**Presentation to
The Federal Aviation Administration**

**In Regard to
The City of Chicago Benefit-Cost Analysis
In Support of Its Proposed O'Hare Modernization Program**

**Dr. Brian M. Campbell, Chairman
Rex J. Edwards, Senior Associate
James Lundy, Senior Analyst**

**Washington, D.C.
July 21, 2005**

With Delay-based Constraint, *OMP-Phase 1 Airfield* Would Have Significant Travel Time Disbenefits (Based on 2002 TAF)

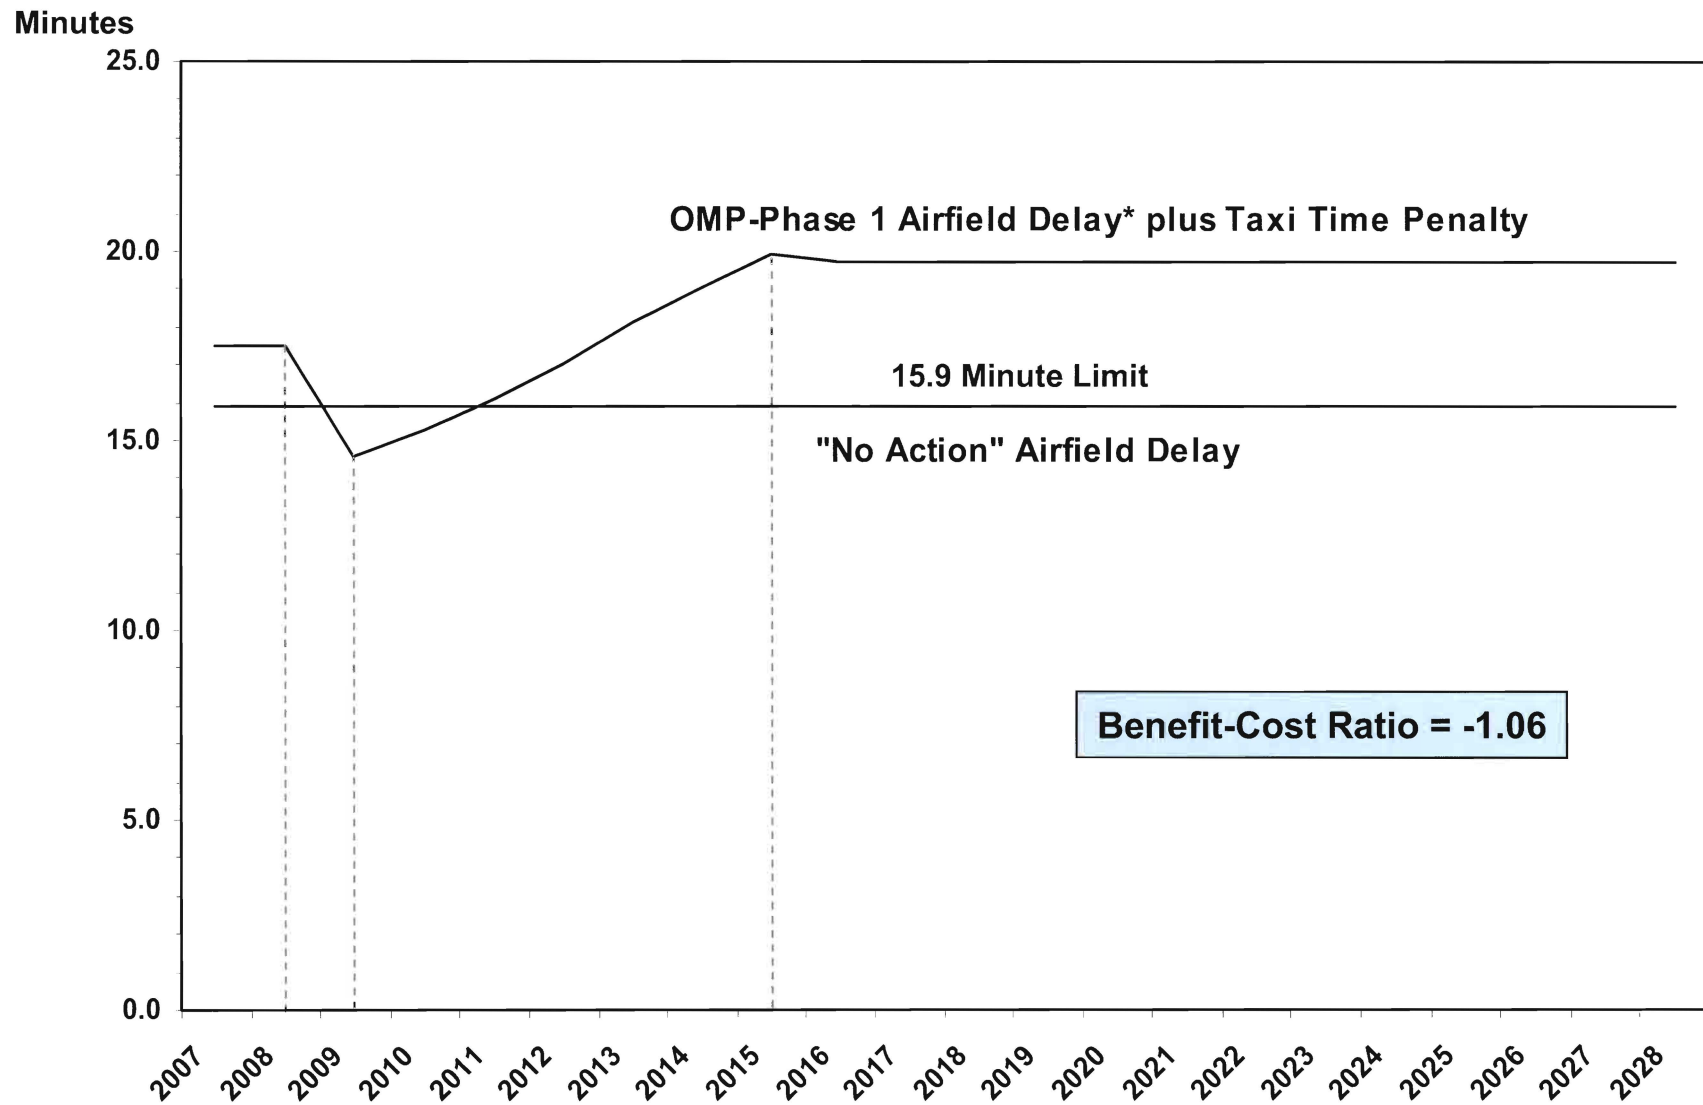
* Delay estimates are based on delay curves derived from TAAM model results with no adjustments.

Using 2003 TAF, *OMP-Phase 1 Airfield* Would Have a Travel Time Disadvantage for the Entire Forecast Period

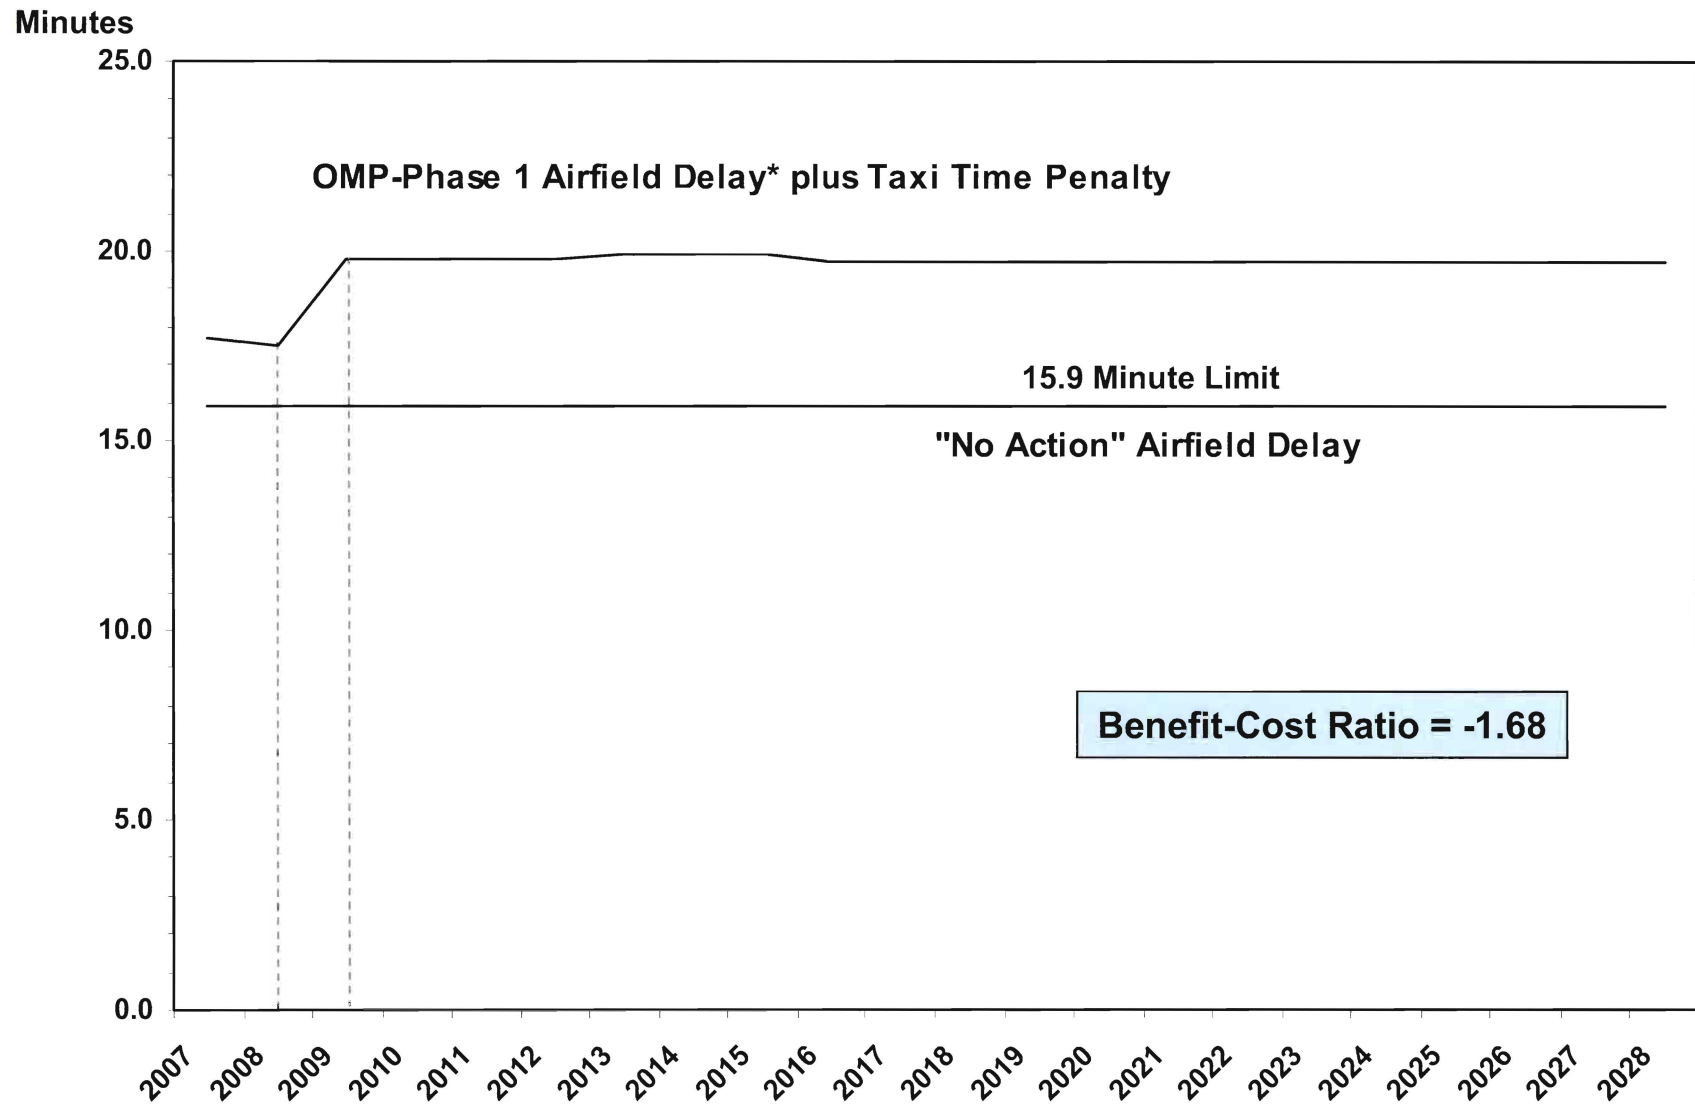
* Delay estimates are based on delay curves derived from TAAM model results with no adjustments.

Using Delay-based Constraint, *Total Master Plan* Would Have a Limited Travel Time Advantage Over “No Action” Airfield (Based on 2002 TAF)

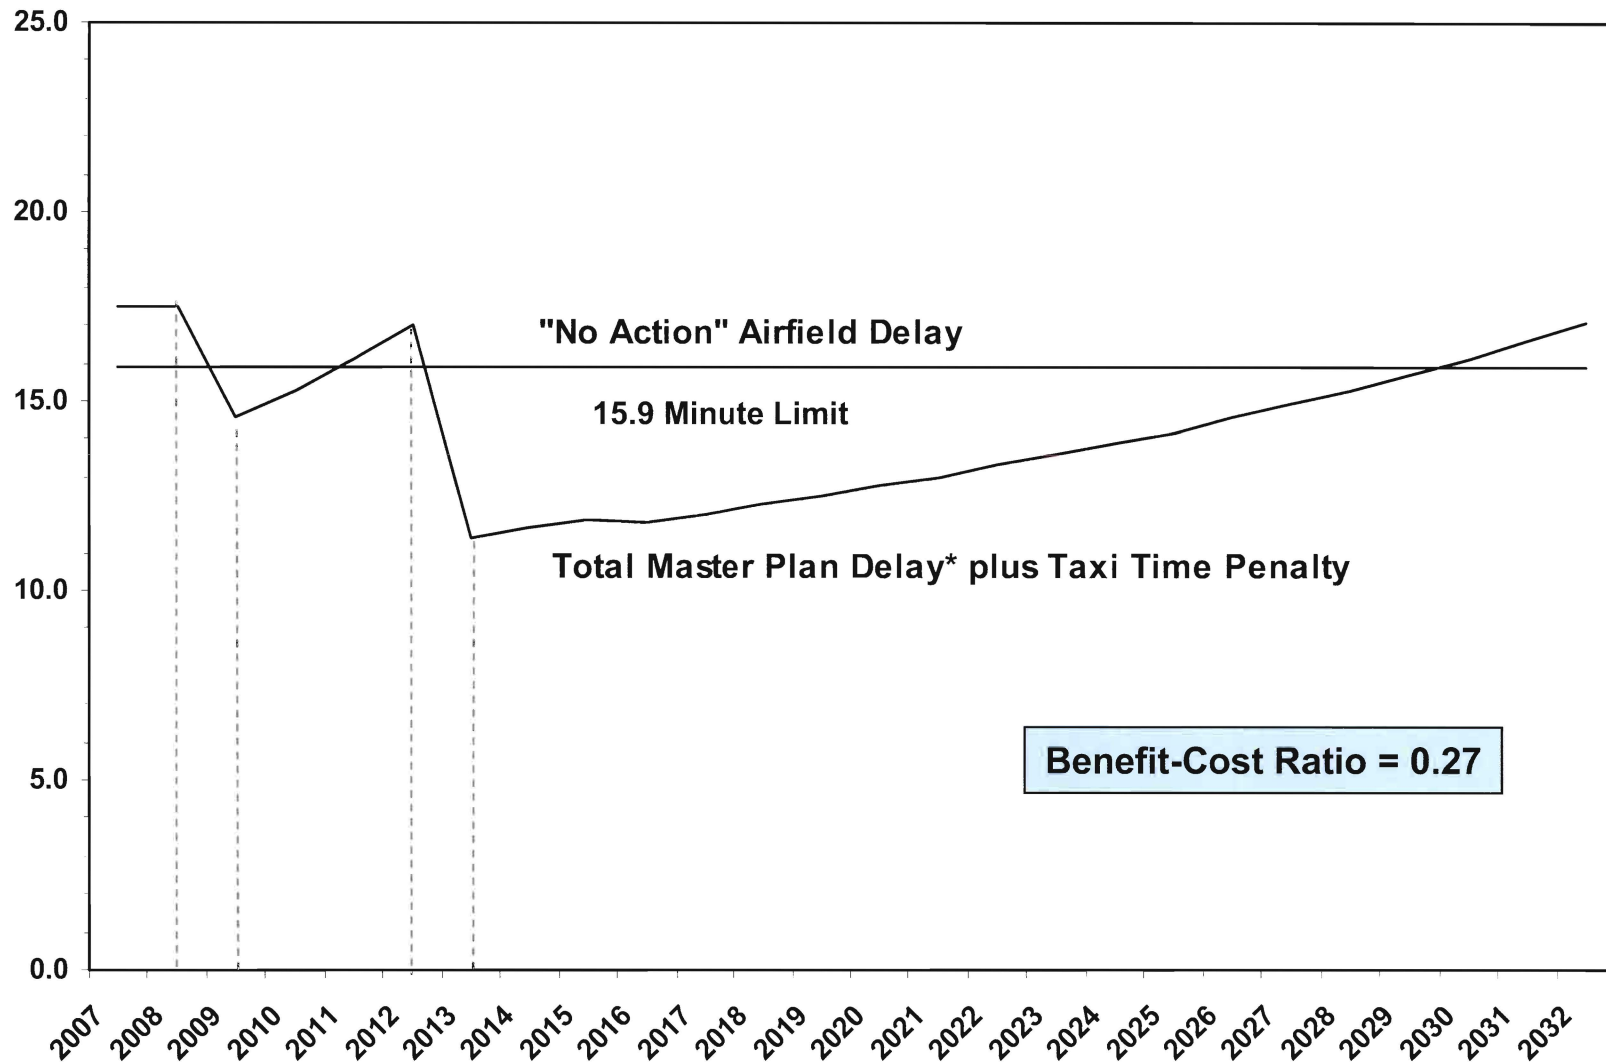
* Delay estimates are based on delay curves derived from TAAM model results with no adjustments.

Using 2003 TAF, The *Total Master Plan* Would Have An Advantage Over “No Action” Airfield for Only 4 Out of 26 Years

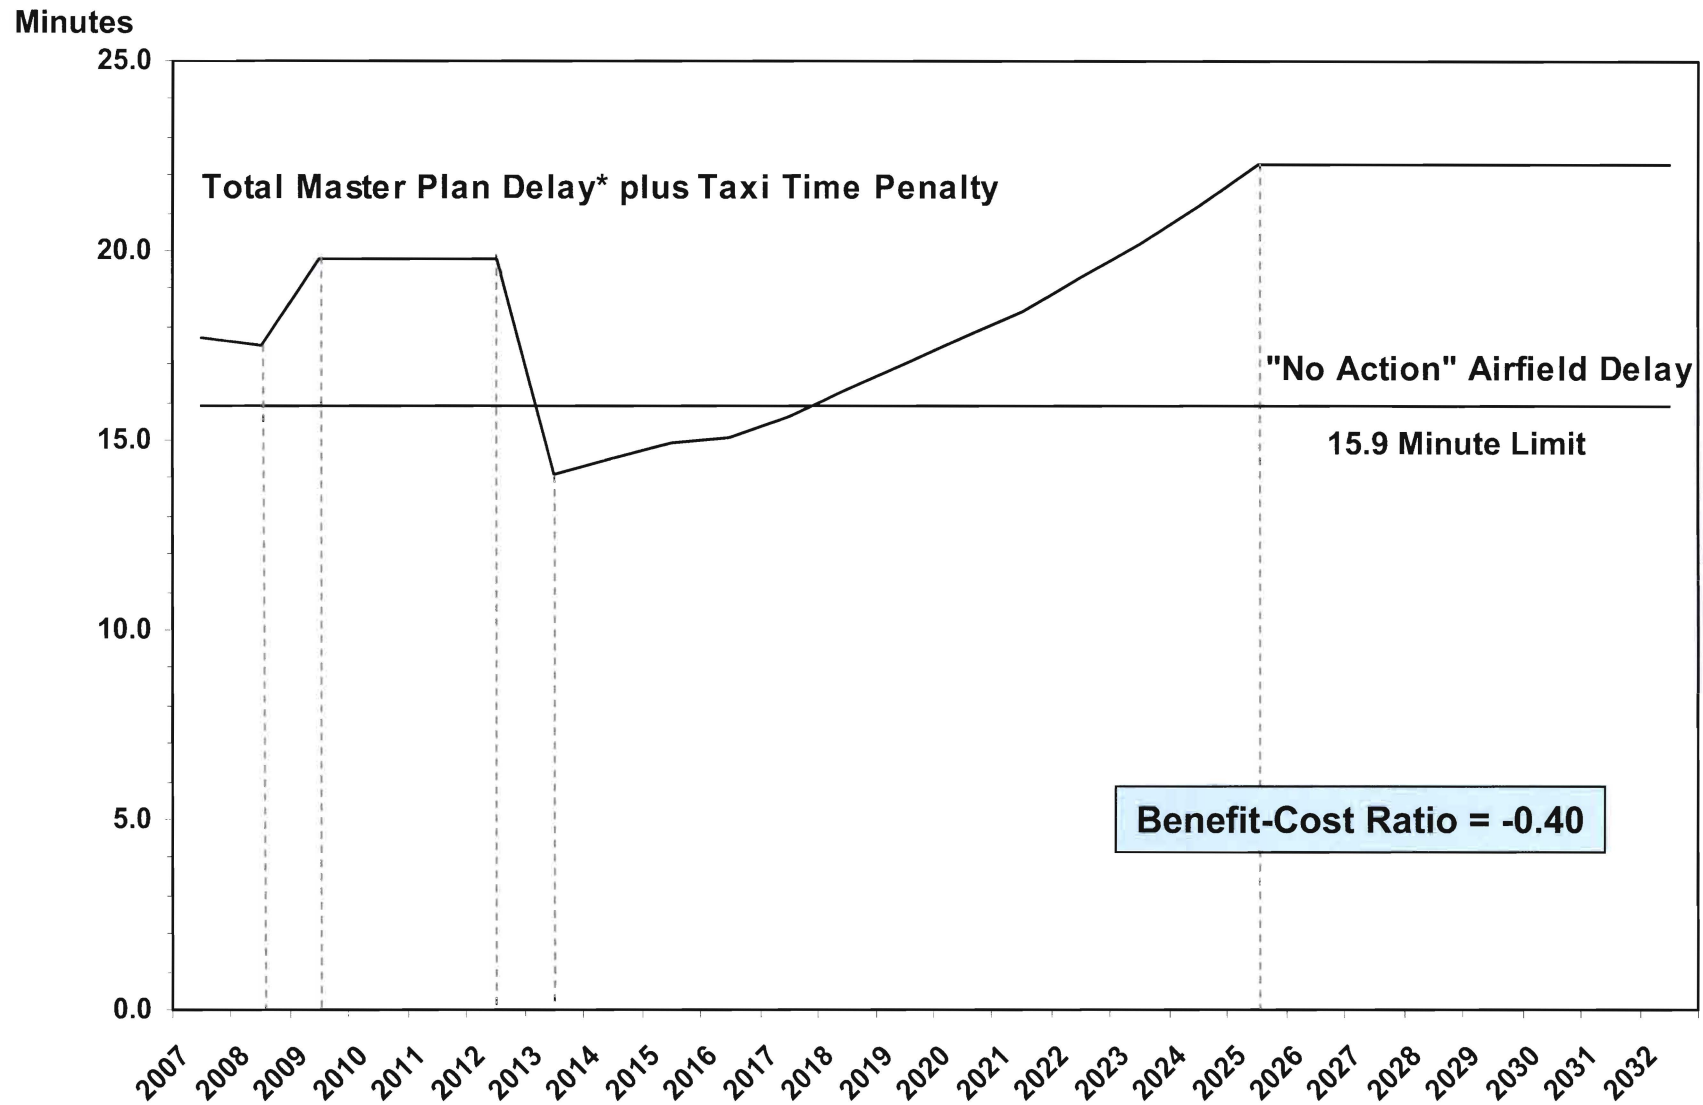
* Delay estimates are based on delay curves derived from TAAM model results with no adjustments.
